ARCHITECT'S SUPPLEMENTAL INSTRUCTIONS

PROJECT:	The Residence at Veterans Park New Senior Development Knoxville, IA	Report No.	Eight (8)
OWNER:	OPG Veterans Park Partners, LLC Dan Maximuk 250 N. Santa Fe Ave, Suite A Salina, KS 67401	Date	Jan. 27, 2026
CONTRACTOR:	Overland Construction Company 250 N. Santa Fe Ave, Suite A Salina, KS 67401	Architect's Proj No.	24-3400
		Contract For:	General Construction Mechanical, Electrical

1. Revised Architectural Sheets A3.1 and A5.1
2. Supplementary Sheet A

A3.1

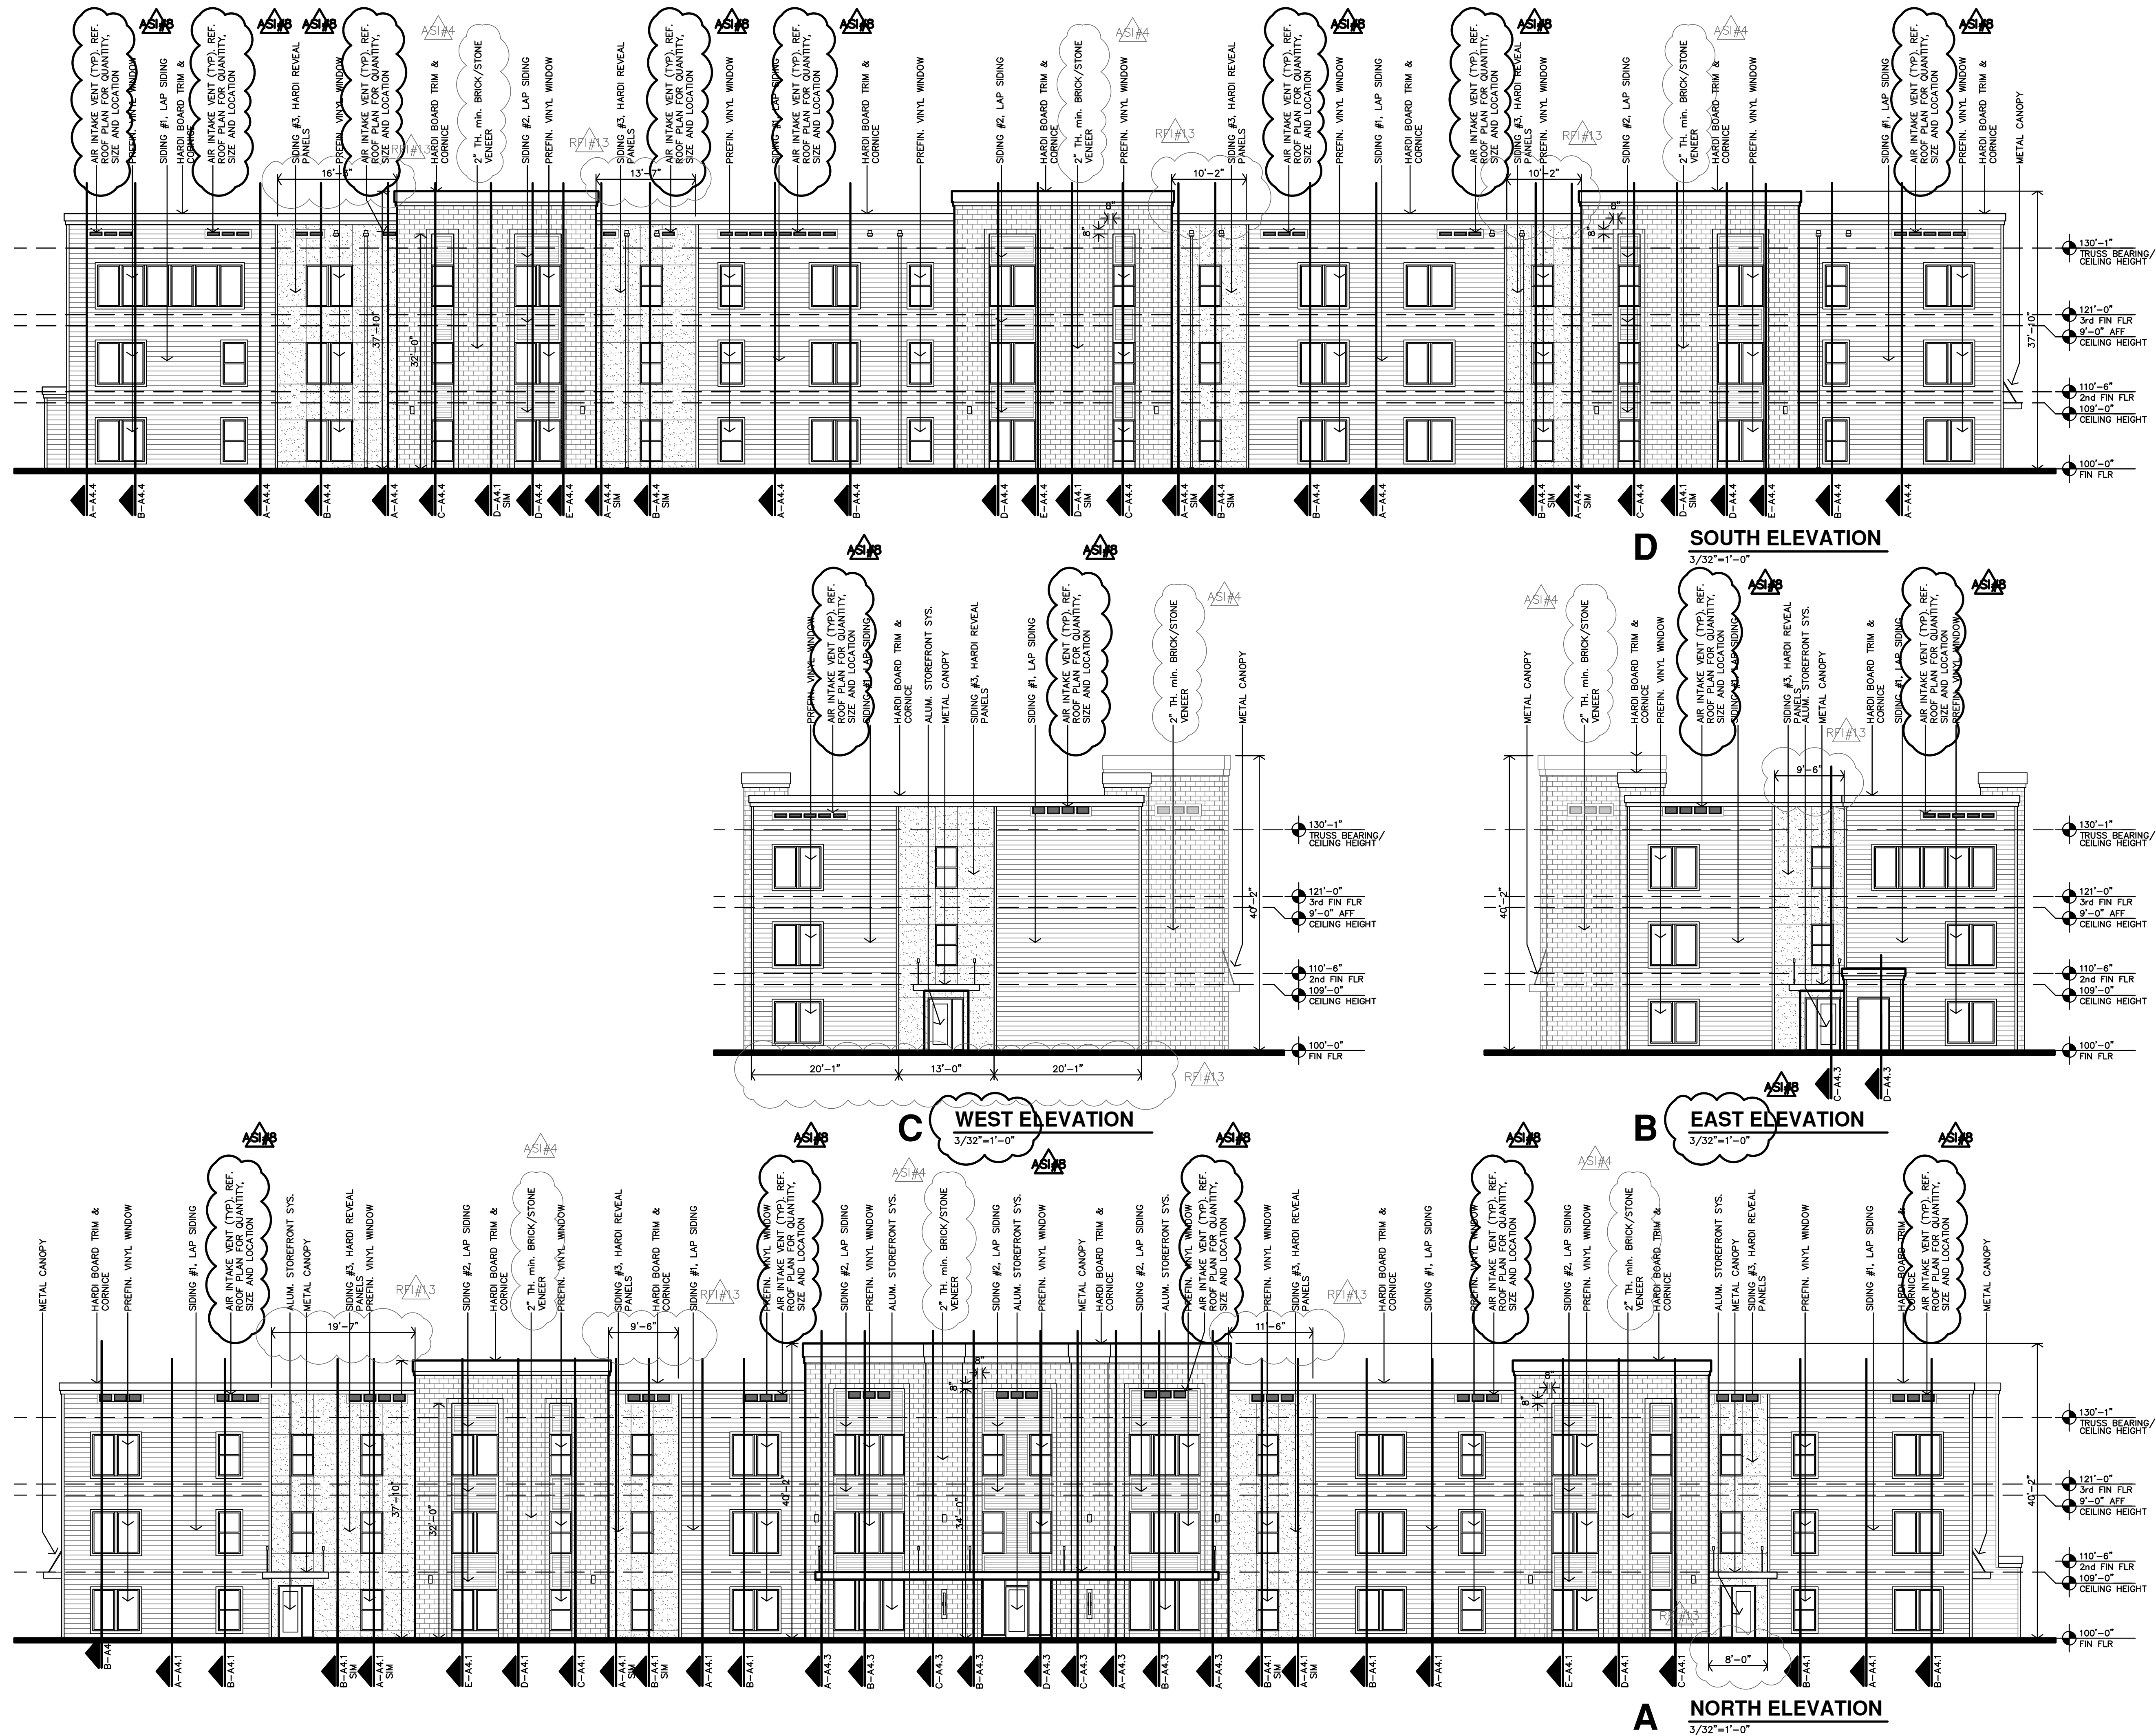
- 1) Passive Wind-driven rain louvers/air intake vents have been added in the attic space at the exterior walls of the building.
 - a.) Sheet A3.1 – air intake vents locations have been added to the exterior elevations
 - b.) Sheet A5.1
 1. Note 17 has been added to the General Notes
 2. Notes 8, 9 & 10 have been added to the Legend
 3. Symbols for the Gravity Ventilators and Wind-Driven Rain Louvers have been added to the Legend.
 4. Attic Ventilation calculations have been reworked.
 5. Roof plan has been revised – Wind-driven rain louvers were added and gravity ventilators were reconfigured.
 - c.) Supplementary Sheet A
 1. Added revised detail E-A4.6 to show location and installation of wind-driven rain louvers.
